**CITY OF LA VISTA
MAYOR AND CITY COUNCIL REPORT
DECEMBER 18, 2018 AGENDA**

Subject:	Type:	Submitted By:
APPLICATION FOR PUD SITE PLAN – LOT 1, SOUTHPORT EAST REPLAT FIVE (NW OF WESTPORT PKWY)	◆ RESOLUTION ORDINANCE RECEIVE/FILE	CHRISTOPHER SOLBERG CITY PLANNER

CASE NUMBER: PPUD-18-0005

RE: Hooters Restaurant
Proposed Planned Unit Development (PUD) Site Plan Amendment - Initial
Review

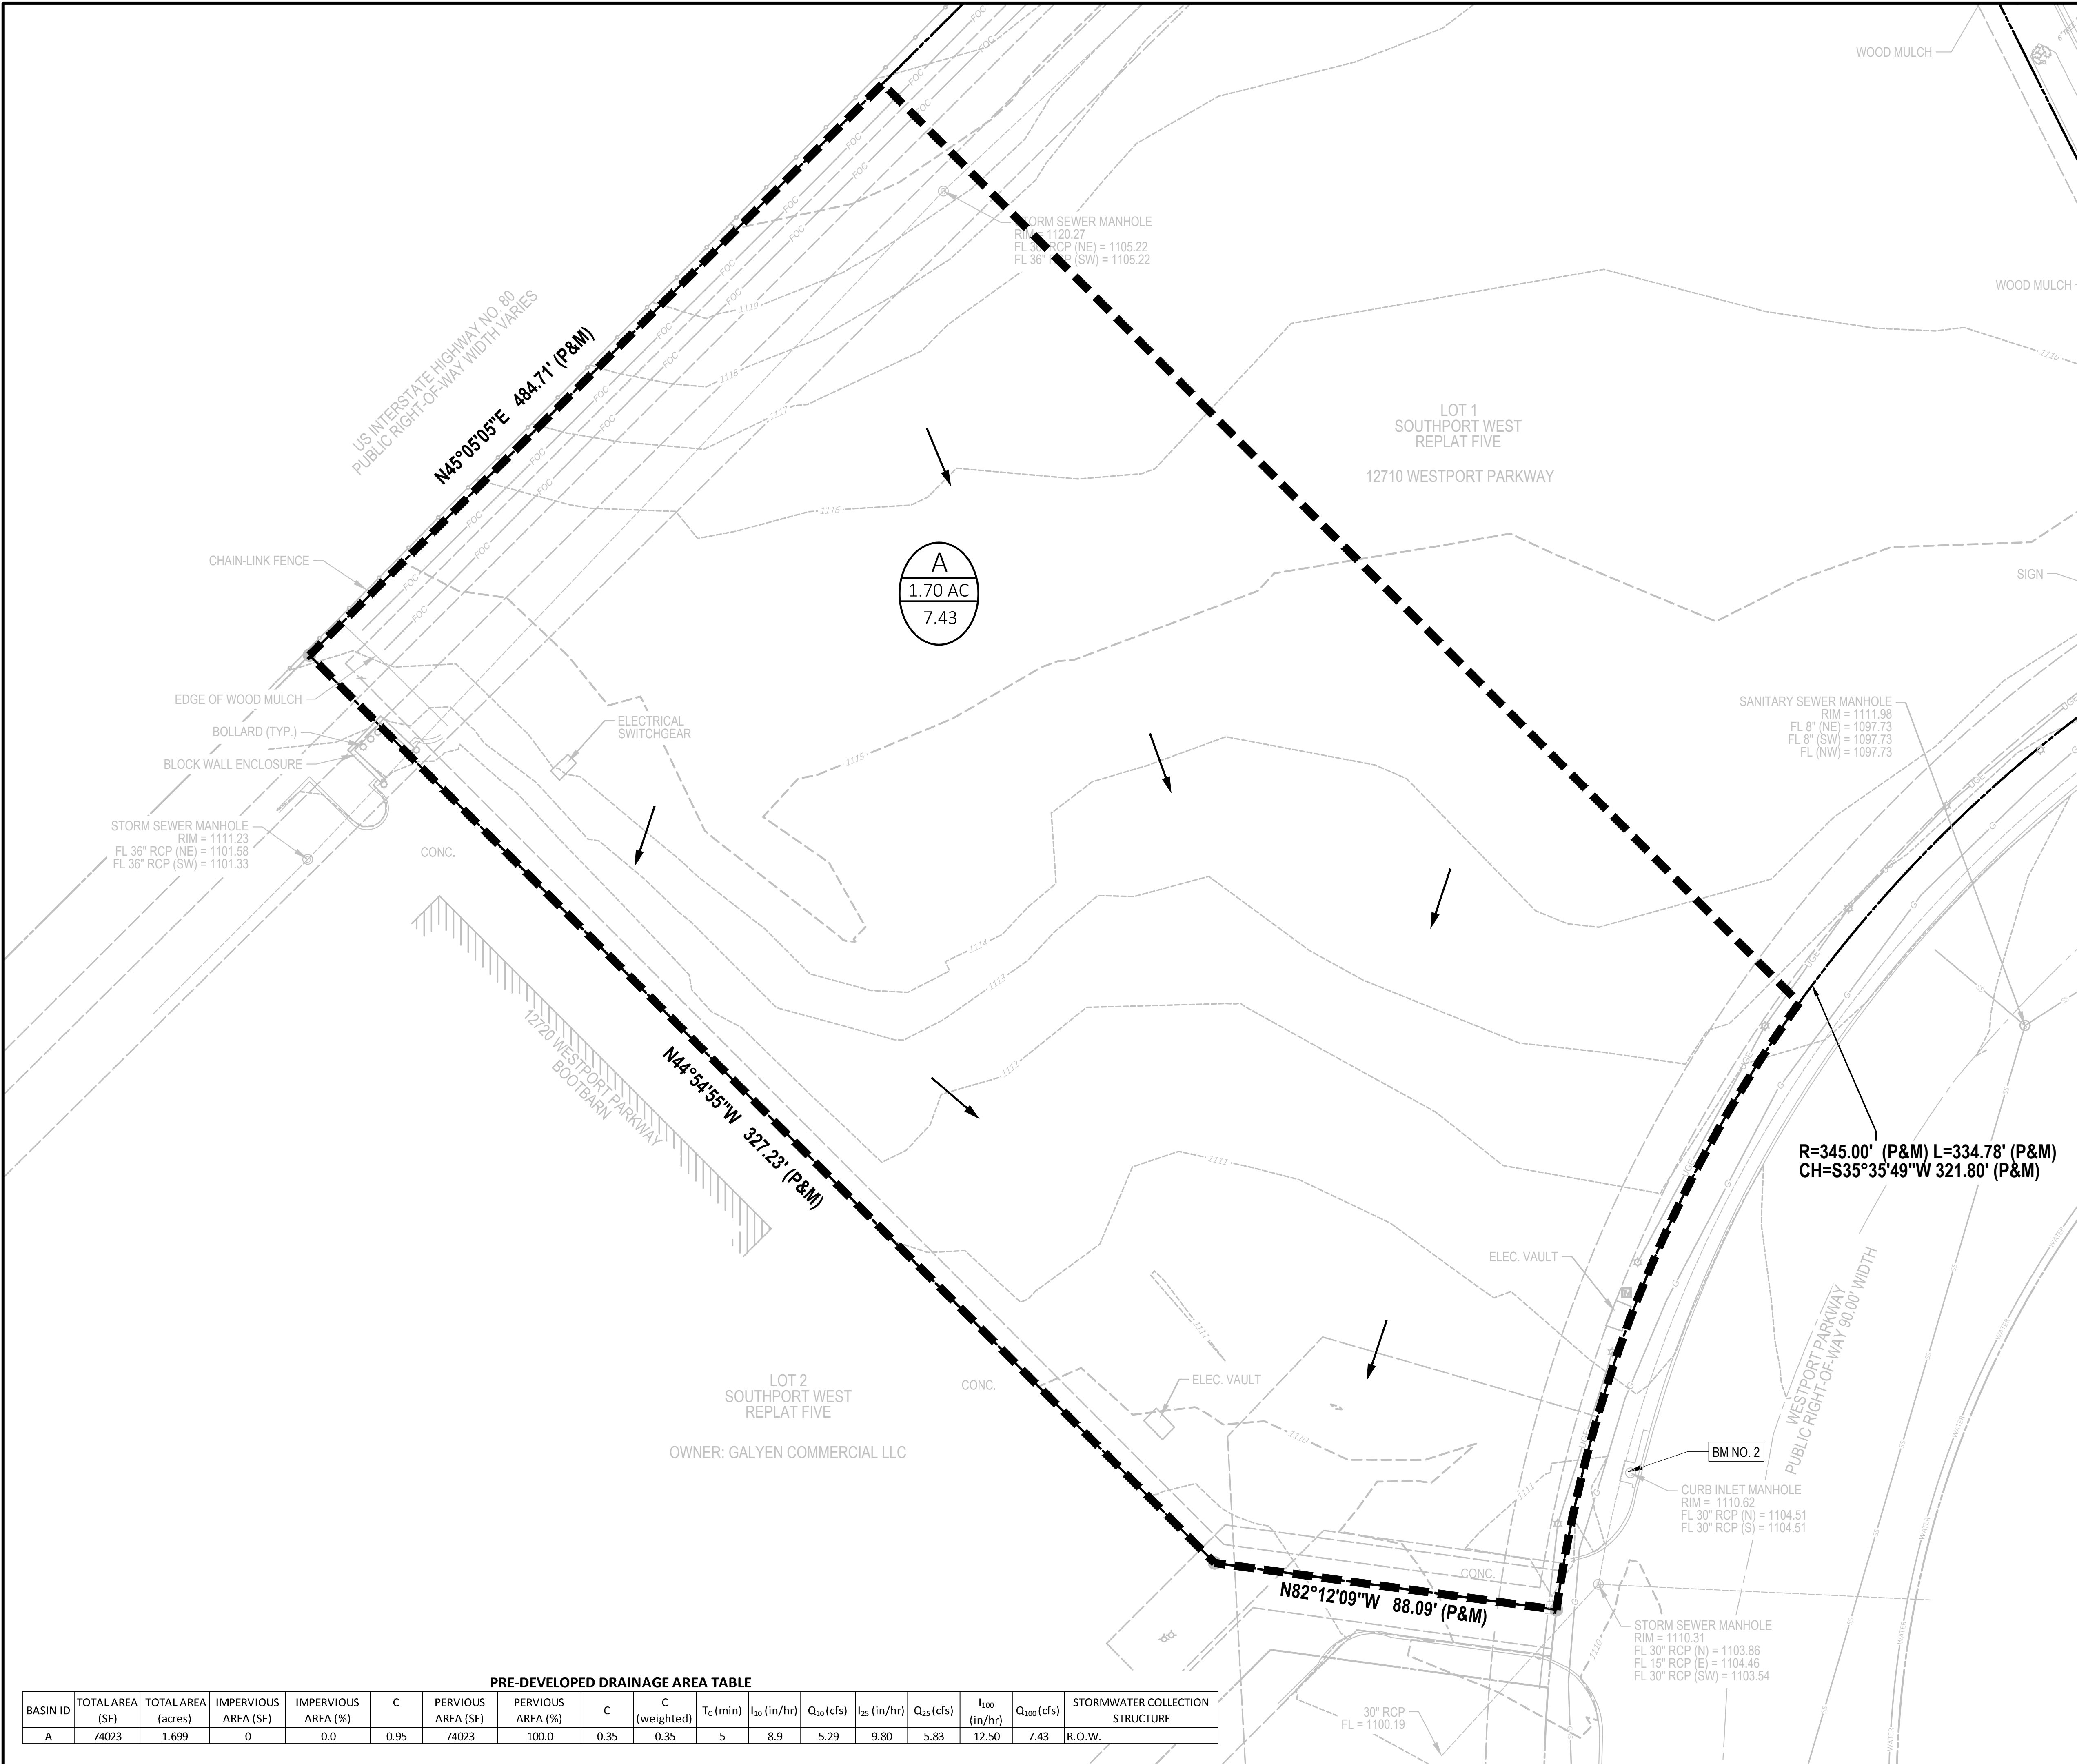
7. The grading plan submitted does not depict the required berming of the landscaped areas along Westport Parkway as required per Section 8(B) (ii) (c) of the Southport West PUD.

The plan set has been updated to show a bermed landscape area along the Hooters frontage.

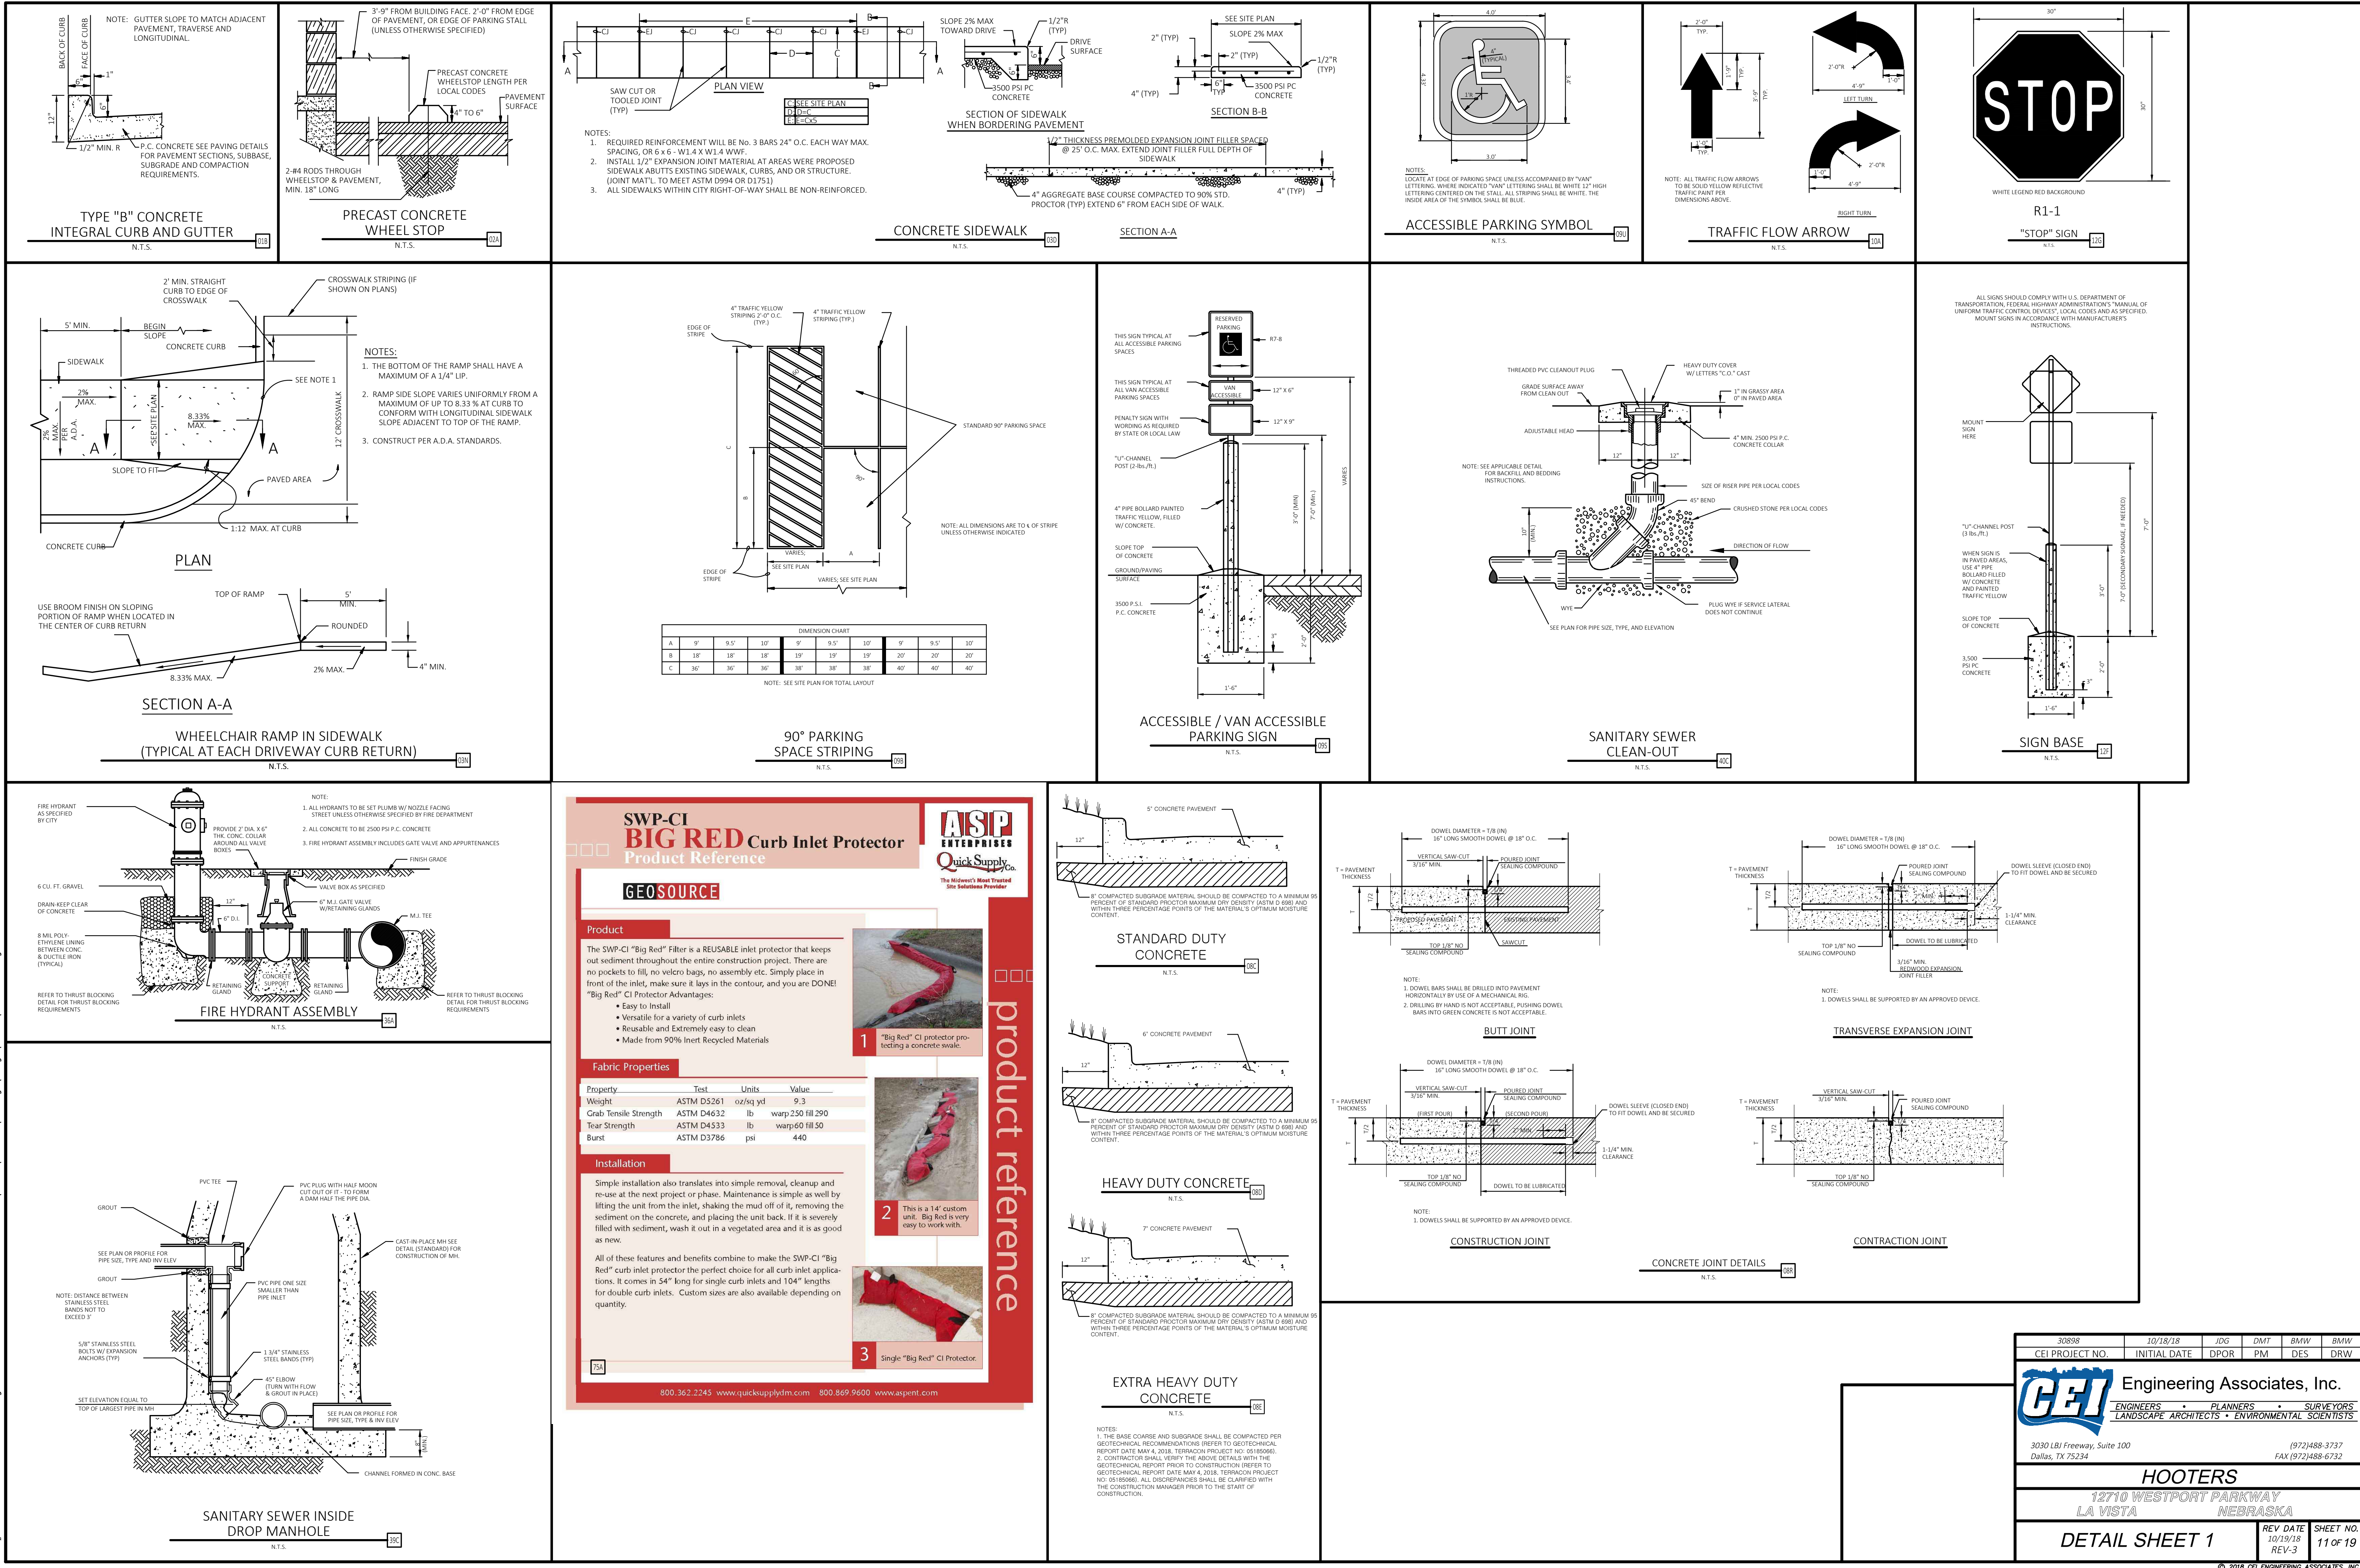
4. Article 5.15.04.04: The Papillion Fire Marshall's office requires the provision of a separate Emergency Vehicle Access Plan which includes Site Plan, Fire Lane, Fire Hydrants, PIV, and FDC - Use Auto-Turn Professional, or similar program, using specifications provided by Fire Marshal.

The revised plans include an Emergency Vehicle Access Plan sheet.
